Preliminary Consultation
MONTGOMERY COUNTY HISTORIC PRESERVATION COMMISSION
STAFF REPORT

Address:	7212 Carroll Ave., Takoma Park	Meeting Date:	4/10/18
Resource:	Contributing Resource Takoma Park Historic District	Report Date:	4/3/18
Applicant:	Manjit & Guru Singh	Public Notice:	3/28/17
Review:	Preliminary Consultation	Staff:	Dan Bruechert
Proposal:	Rear Addition, hardscape and other alterations

Figure 3: The Historic Takoma building has decorative brickwork above the storefront transom.

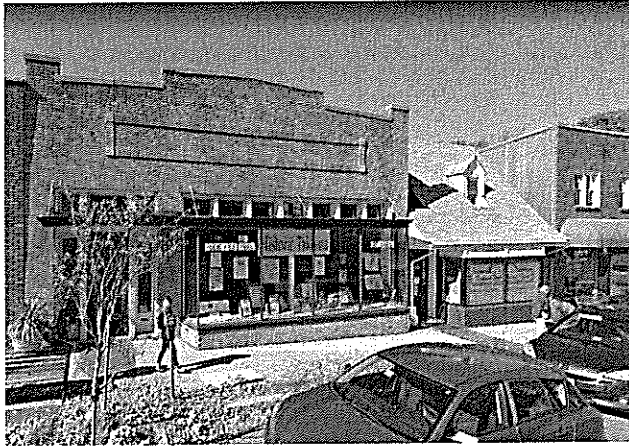
4. A small decorative element consistent with the images shown in Fig. 1 – 3 (below) needs to be added above the second-floor windows to break up the interrupted wall plane. Elevation drawings showing the inclusion of this feature must be submitted for review and approval with final approval authority delegated to Staff.

While some Commissioners expressed their desire for a striped-down and simplified form, Staff finds that, in an attempt to have the proposed construction not visually compete with the historic building, the design now creates a blank wall that has remove all ornamentation above the belt course. Staff finds that the replication of one of the design elements shown above (see Fig 1 – 3) or a similar detail would make the proposal more consistent with 24A-8(b)(2). Staff recommends the Commissioners work with the applicant to identify an appropriate design solution for this building element.

4. A small decorative element consistent with the images shown in Fig. 1 – 3 (below) needs to be added above the second-floor windows to break up the interrupted wall plane. Elevation drawings showing the inclusion of this feature must be submitted for review and approval with final approval authority delegated to Staff.

BIRDS EYE VIEW-EXISTING W/ NEW

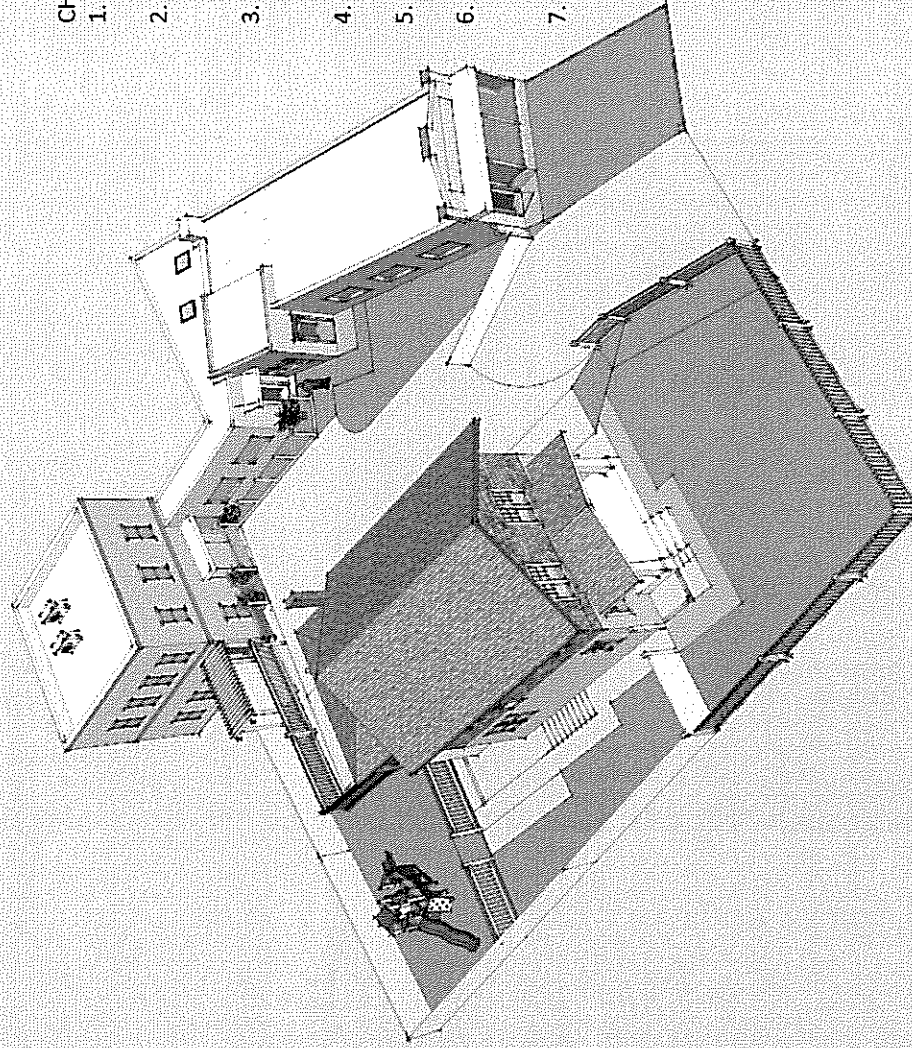
CHANGES MADE TO DESIGN:

1. BUILDING HEIGHT REDUCED BY 1'-6" TOTAL. AS RECOMMENDED BY HPC
2. BRICK COLOR MODIFIED TO REPRESENT A MORE ACCURATE TEXTURE OF EXISTING & NEW AS SUGGESTED BY .
3. WINDOWS ADDED TO SIDE & REAR OF 2-STORY BUILDING AS SUGGESTED BY HPC & FAÇADE REVIEW COMMITTEE.
4. CMU BLOCK COLOR MODIFIED AS SUGGESTED BY HPC.
5. BRICK FACE RETURNED TO SIDES & REAR AS SUGGESTED BY FAÇADE REVIEW COMMITTEE.
6. FENCE GRAPHICS UPDATED TO REPRESENT A MORE ACCURATE DESIGN AS SUGGESTED BY FAÇADE REVIEW COMMITTEE.
7. CONDENSORS & SKYLITES ADDED FOR REFERENCE TO ROOFS OF NEW BUILDING STRUCTURE.
